Access Compliance Report

Public Rights-of-Way

Intersection ID: 43573	Main Street: JOHN_KOLB_DR	Cross Street: MARSH_RD	Location: SW
ADA ID: 581D1D2315F0	Ramp Type: BlendTrans1	Initial Pass/Fail: Fail	Overall Compliance: No
Severity Score: 8.75			
Codes/Mitigation Info/Possible Solution		Field Measurements/Component Compliance

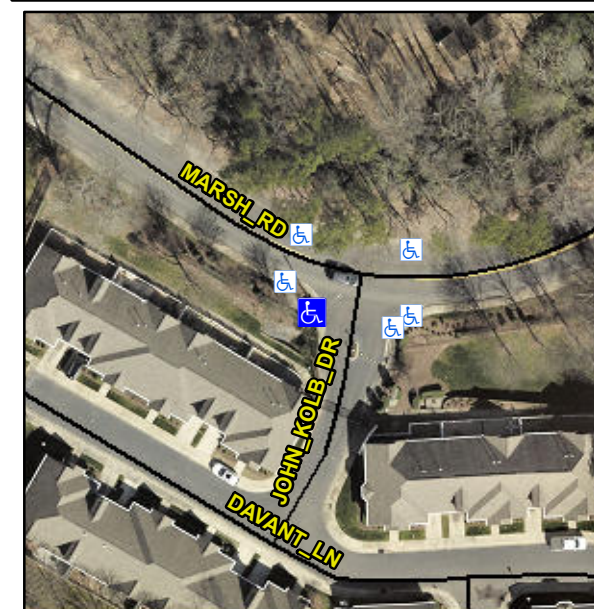
Not Found, R304.5.1

Compliance	Description	Data	Compliance	Description	Data
N/A	Ramp Length (in)	47.0	Yes	BlendTrans Slope (%)	3.0
No	Ramp Width (in)	46.0	Yes	BlendTrans XSlope (%)	0.2
N/A	Flare Type LT	N/A	N/A	Flare Type RT	N/A
N/A	Flare Slope LT (%)	N/A	N/A	Flare Slope RT (%)	N/A
N/A	Flare Traversable LT?	N/A	N/A	Flare Traversable RT?	N/A
N/A	Landing Length (in)	N/A	N/A	DWS Provided?	N/A
N/A	Landing Width (in)	N/A	N/A	DWS Contrast?	N/A
N/A	Landing Slope (%)	N/A	N/A	DWS Length (in)	N/A
N/A	Landing X Slope (%)	N/A	N/A	DWS Full Width?	N/A
N/A	Landing Curb? (Y/N)	N/A	N/A	DWS Offset (in)	N/A
N/A	Shared Landing?	N/A			
N/A	Gutter Ponding?	N/A	N/A	Gutter Slope (%)	N/A
N/A	Gutter Lip Ht (in)	N/A	N/A	Gutter X Slope (%)	N/A
N/A	Painted X Walk1?	No	N/A	Painted X Walk2?	N/A
	X Walk 1 Direction	To E		X Walk 2 Direction	N/A
	X Walk 1 Width (in)	N/A		X Walk 2 Width (in)	N/A
	X Walk 1 Slope (%)	3.4		X Walk 2 Slope (%)	N/A
	X Walk 1 X Slope (%)	6.0		X Walk 2 X Slope (%)	N/A

N/A	Ramp inside XWalk1?	N/A	N/A	Ramp inside XWalk2?	N/A
	Road Slope (%)	6.0		Clear Space?	N/A
	Road X Slope (%)	3.4	N/A	Clear Space to XWalk (in)	N/A
N/A	Any Obstructions?	N/A	N/A	Storm Grate/Utility Hazard?	N/A
	Obstruction Type			Storm Grate/Utility Type	
		N/A			N/A
			Yes	Surface Condition? (G/P)	Good
			No	Curb Slope (%)	13.8

Remove & Replace Curb Ramp With Two New Directional Ramps or Equivalent.
